**METROPOLITAN GOVERNMENT OF NASHVILLE AND DAVIDSON COUNTY**

**STAFF RECOMMENDATION**  
**1013 Clayton Avenue**  
**May 16, 2018**

**Application:** New construction-addition; Setback determination  
**District:** Belmont-Hillsboro Neighborhood Conservation Zoning Overlay  
**Council District:** 18  
**Map and Parcel Number:** 118050B00200  
**Applicant:** Matthew Schutz  
**Project Lead:** Melissa Baldock, melissa.baldock@nashville.gov

Figure 1. 1013 Clayton Avenue (the right portion of the duplex)

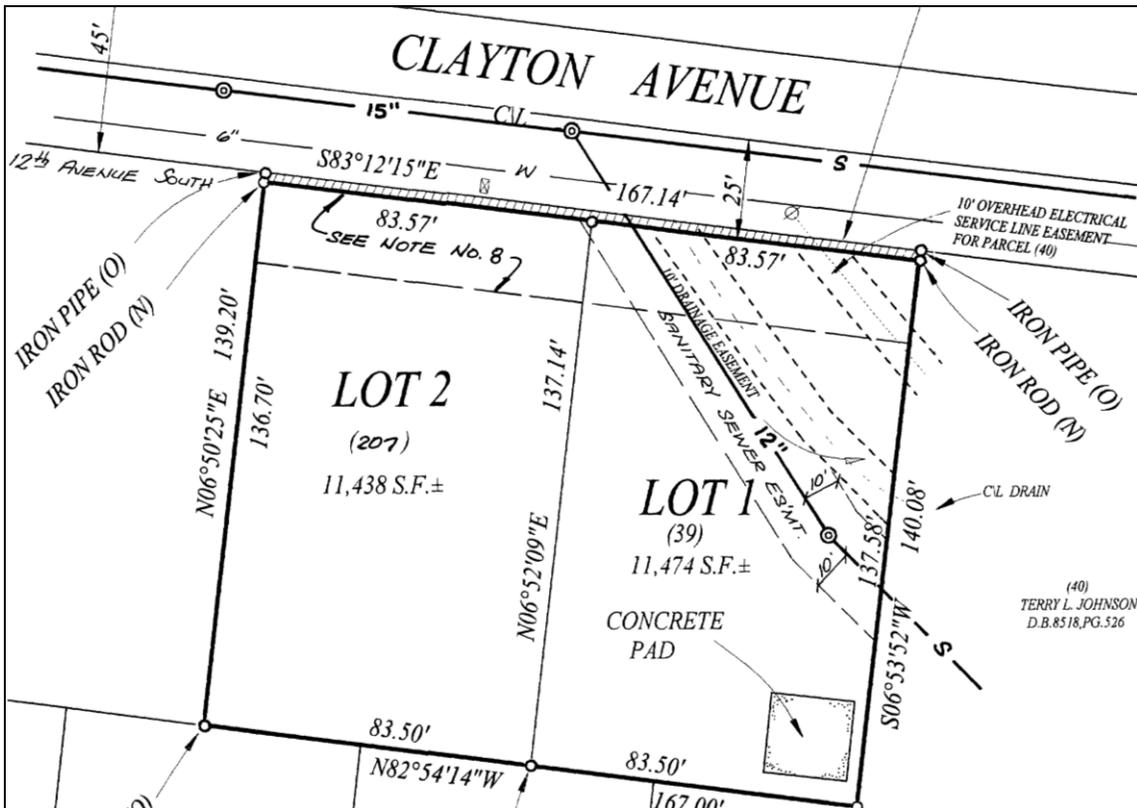
**Background:** 1013 Clayton Avenue is one-half of a non-contributing duplex constructed c. 1996 (Figure 1.). The duplex is setback significantly on the lot because of a stormwater and sewer easements in its front yard (Figure 2).

Figure 2. The 1996 subdivision plot plan for the lot shows the “10’ Drainage Easement” and the “Sanitary Sewer Easement” that runs through the front yard. 1013 Clayton is location on Lot 1 in this image.

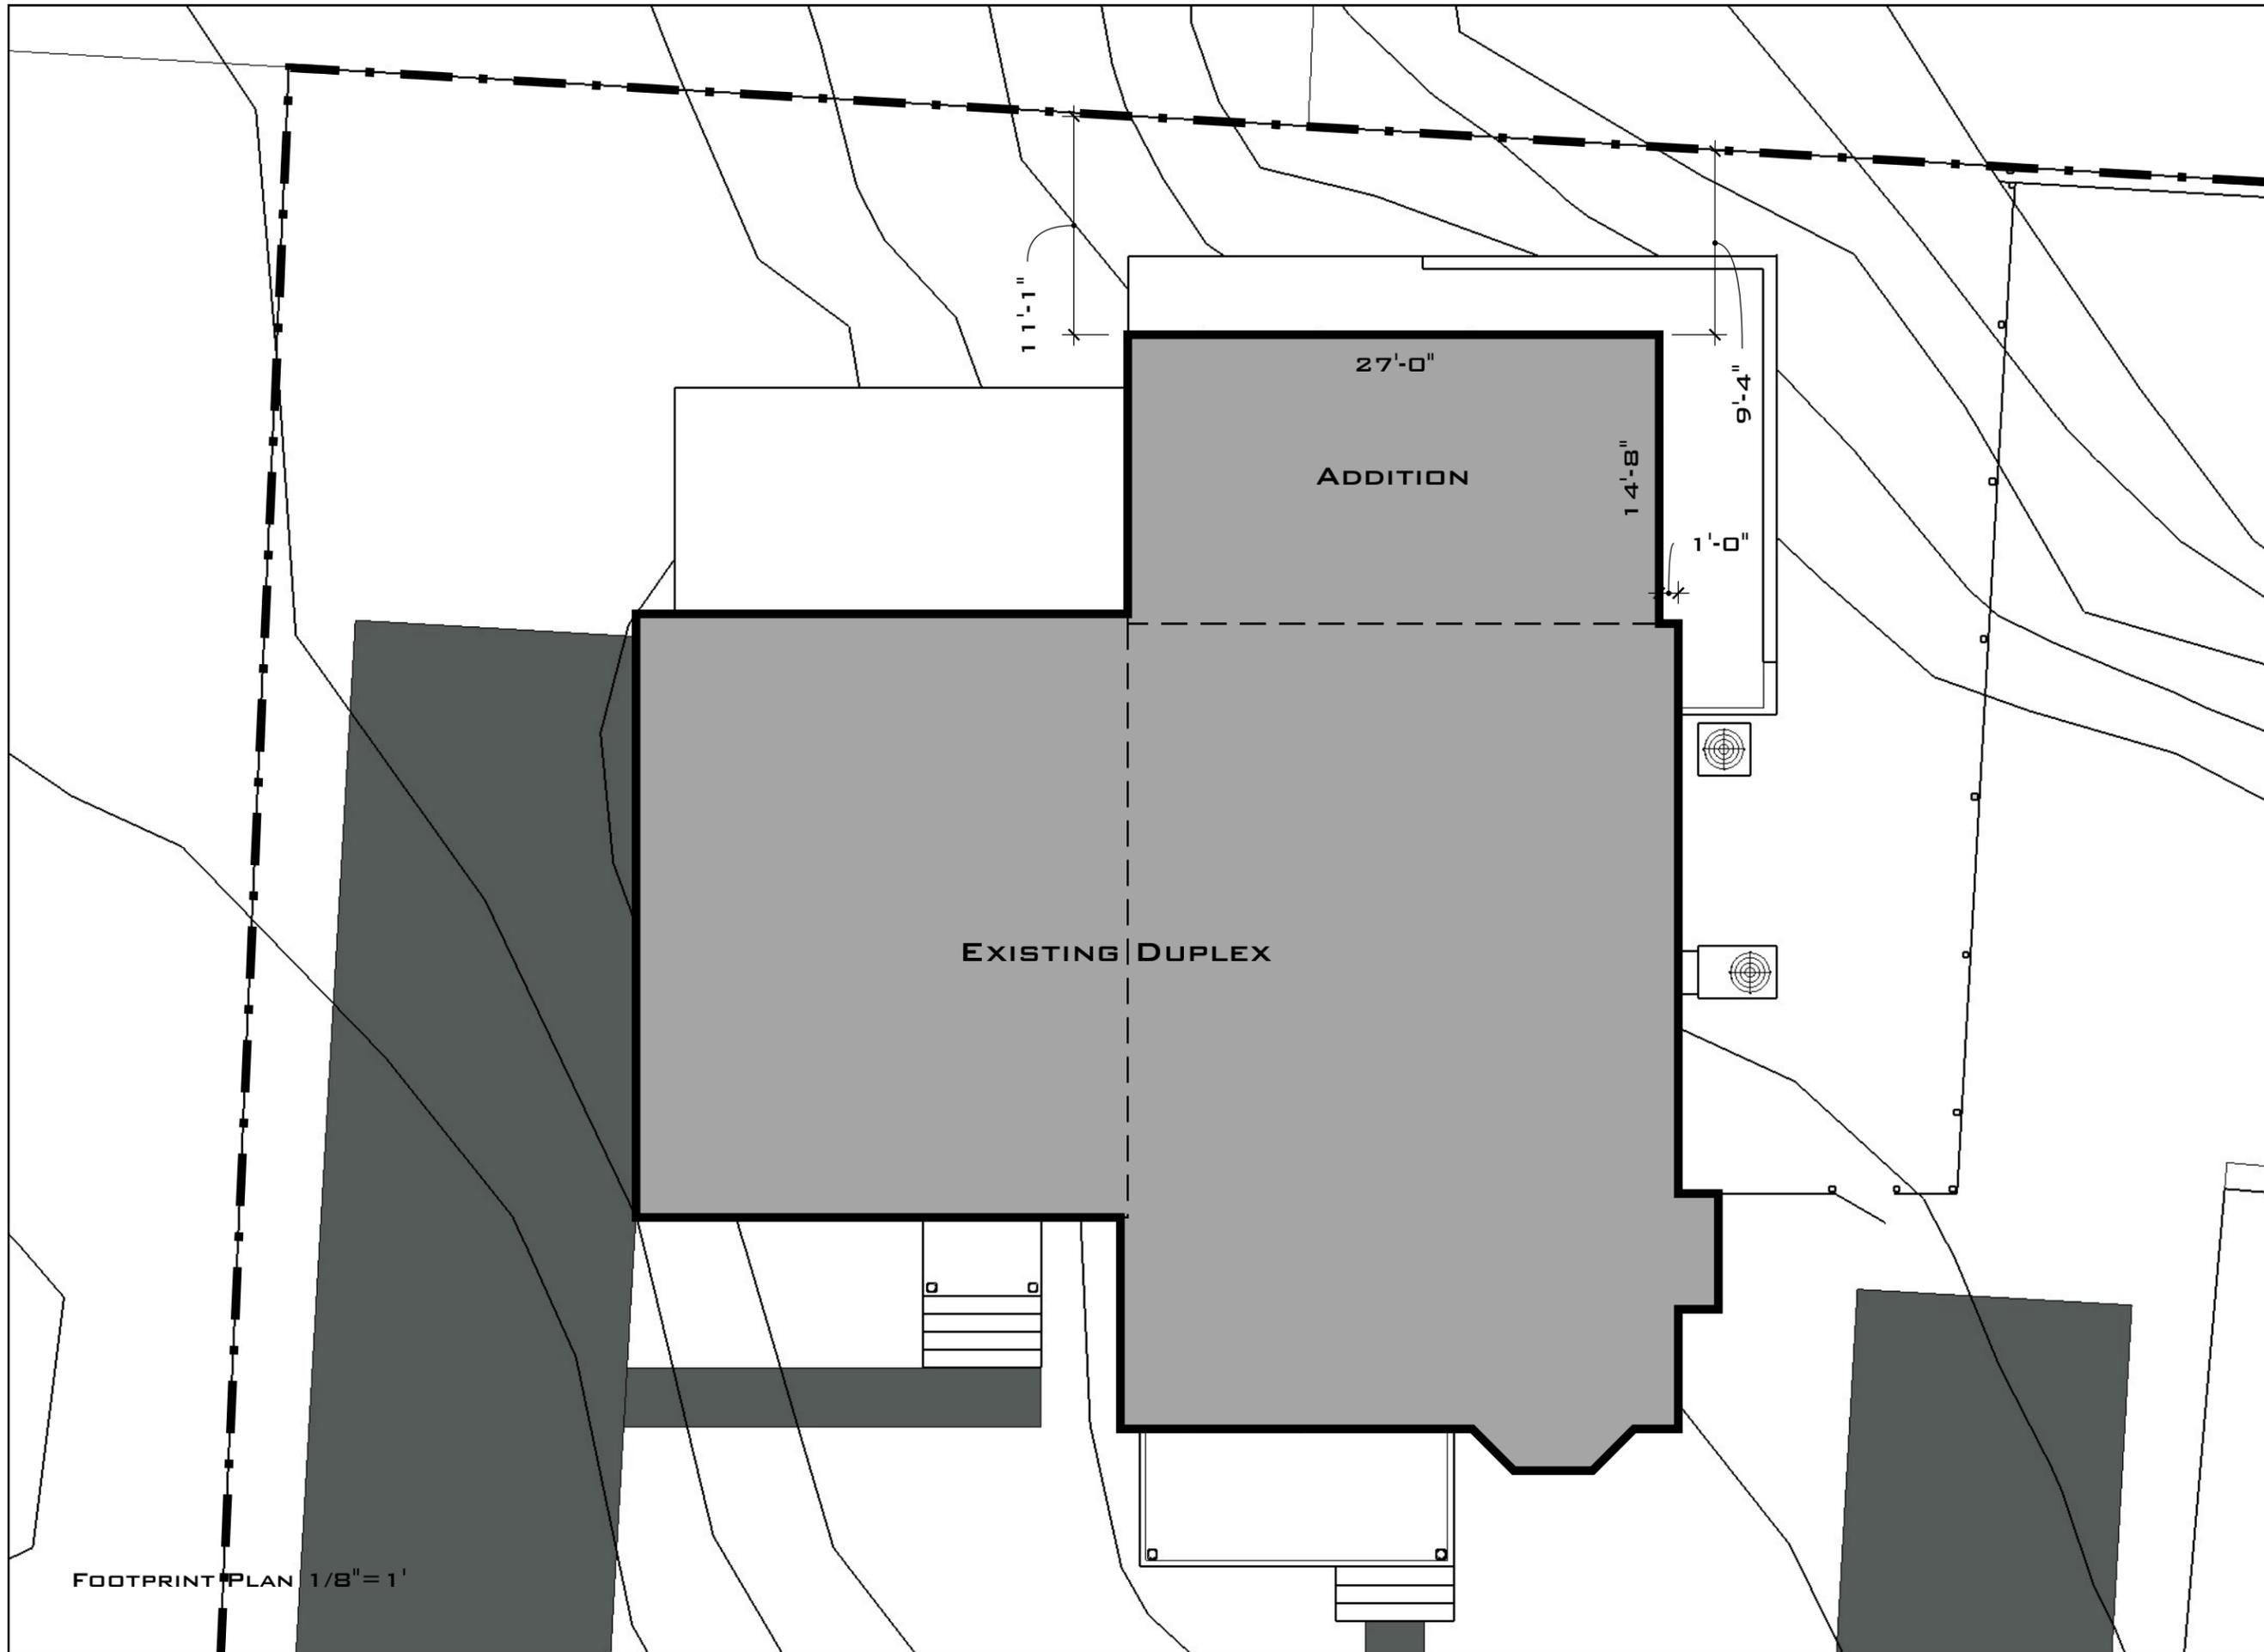
The deep front setback for 1013 Clayton Avenue is the result of stormwater and sewer easements running through the front yard. Because of the deep front setback, the existing house has a shallow rear yard and is located less than twenty-four feet (24') from the rear property line. The proposed addition is modestly scaled, adding less than fifteen feet (15') of depth to the existing house. Because of the peculiarities of the lot and because the addition is modestly scaled, staff finds that the proposed rear setback of nine feet, four inches (9'4") meets the Sections II.B.1.c. and II.B.2. of the design guidelines.
